**Project: IEEE P802.15 Study Group for Wireless Personal Area Networks (WPANs)**

- Submission Title:** PSSS proposal – Parallel reuse of 2.4 GHz PHY for the sub-1-GHz bands
- Date Submitted:** 21th April 2005
- Source:** Andreas Wolf, DWA Wireless GmbH and Hans van Leeuwen, Integration

- Re:** PSSS mode for more even chiprates, simpler filter, and 250 kbit/s in 868 MHz and new less complex preamble.
- Abstract:** Ballot comments received indicated interest in the TG4b task group to modify the PSSS mode for 868 MHz to have the same 250 kbit/s bitrate as the 2.4 GHz and the PSSS 915 Mhz modes. Offering also simpler preamble.

- Purpose:** Response to ballot comments to discuss potential modification of PSSS draft specification
- Notice:** This document has been prepared to assist the IEEE P802.15. It is offered as a basis for discussion and is not binding on the contributing individual(s) or organization(s). The material in this document is subject to change in form and content after further study. The contributor(s) reserve(s) the right to add, amend or withdraw material contained herein.

## Comparision Actual/New Proposed Preamble Length of Proposed Preamble

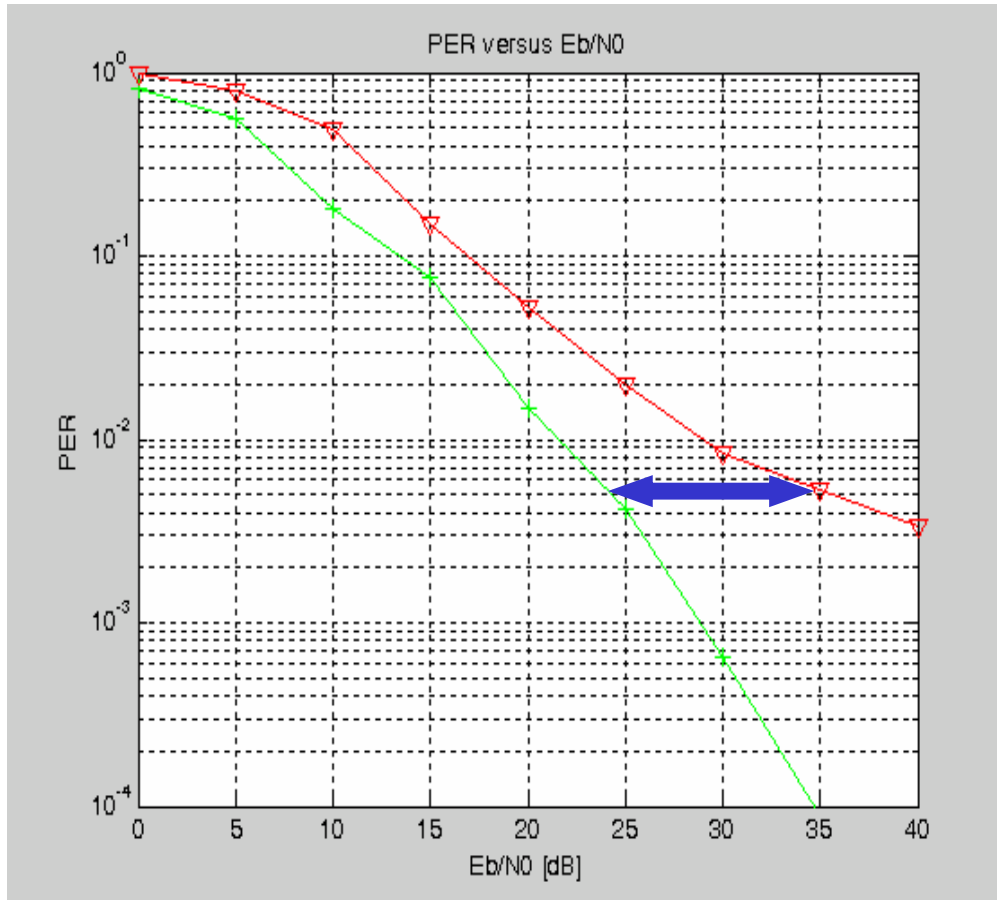
Barker Code	Sequence 0
DC free	<b>yes</b>	<b>yes</b>
32 Chip long	<b>no</b>	<b>yes</b>
# of needed FIR in Rx	<b>2</b>	<b>1</b>

- The Sequence 0 is repeated 8 times for having similar definition like for i.e. 2.4 GHz Phy.

Code length	# of codes	# of repeating	preamble # of chips
Barker Code	<b>13</b>	<b>2</b>	<b>8</b>	<b>208</b>
Sequence 0	<b>32</b>	<b>1</b>	<b>8</b>	<b>256</b>

- We propose to use PSSS 250-400 instead of PSSS 206-440 for ETSI.
- We propose also to use the new preamble base on Sequence  $C_0$  for similar design compared to the other Phys.

# Preamble Detection with current Barker Code

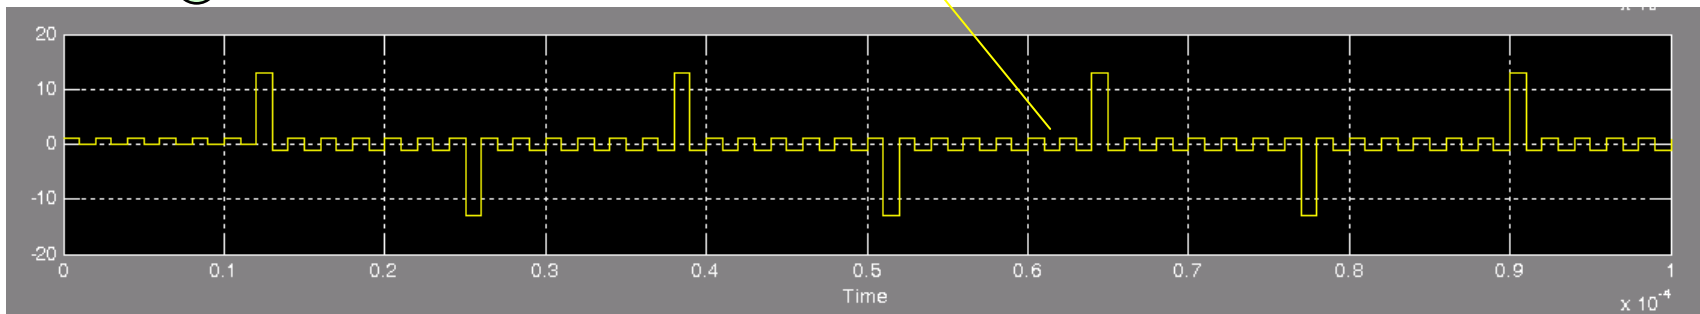
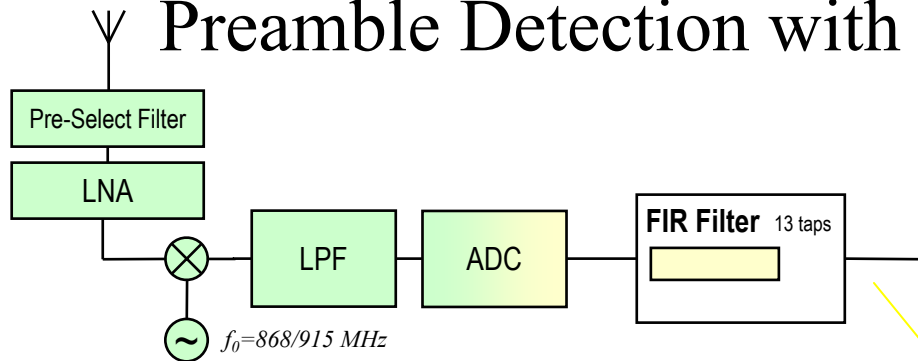
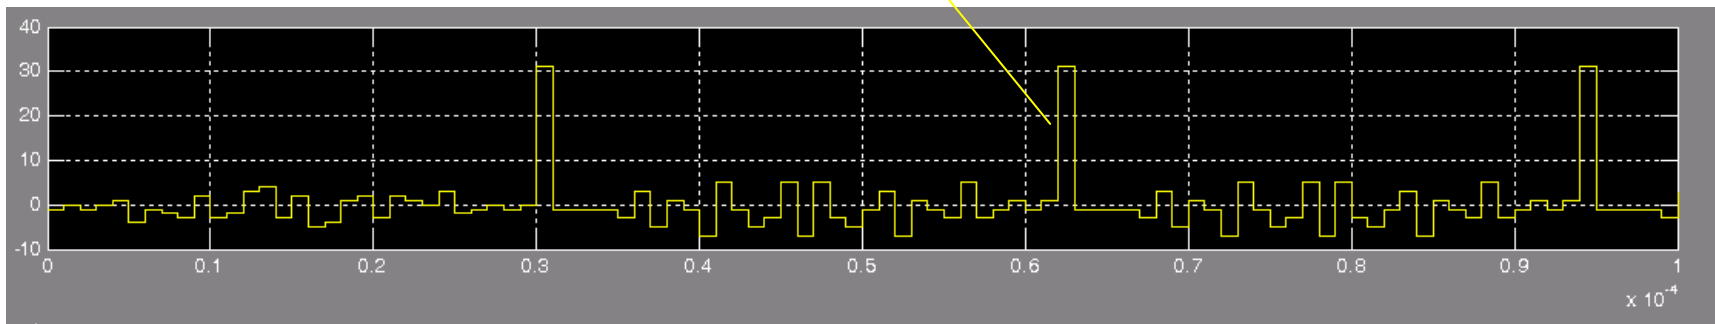
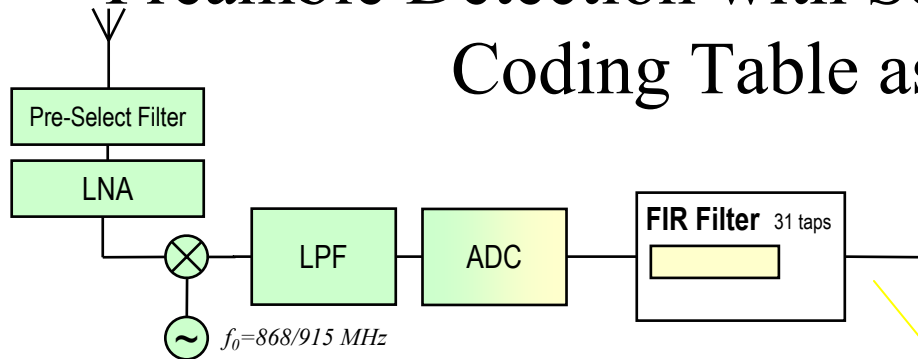
- When detecting the current barker code based preamble with FIR filter, the signal coming out of the FIR filter has side slopes limited to +/- 1.
- Advantages:
  - DC free
- Disadvantages:
  - **Two FIR filters needed**, one for preamble detection (13 chip barker code), one for PSSS decoding (31 chip m-sequence).
  - **Not multiple of symbol duration**

- When detecting the preamble, base on repeated sequence 0 with FIR filter, the signal coming out of the FIR filter has side slopes limited to +5/-6.
- Advantages:
  - Use of just one FIR filter or correlator for preamble detection and PSSS decoding.
  - **32 chip long preamble code.= multiple of symbol duration and similar to other phys.**
  - DC free

- We propose to use Sequence 0 =  $c_0$ , 8 times repeated, instead of the barker code.
- Preamble will then be more similar to the other Phys.
- Preamble length will we multiple of symbol duration.
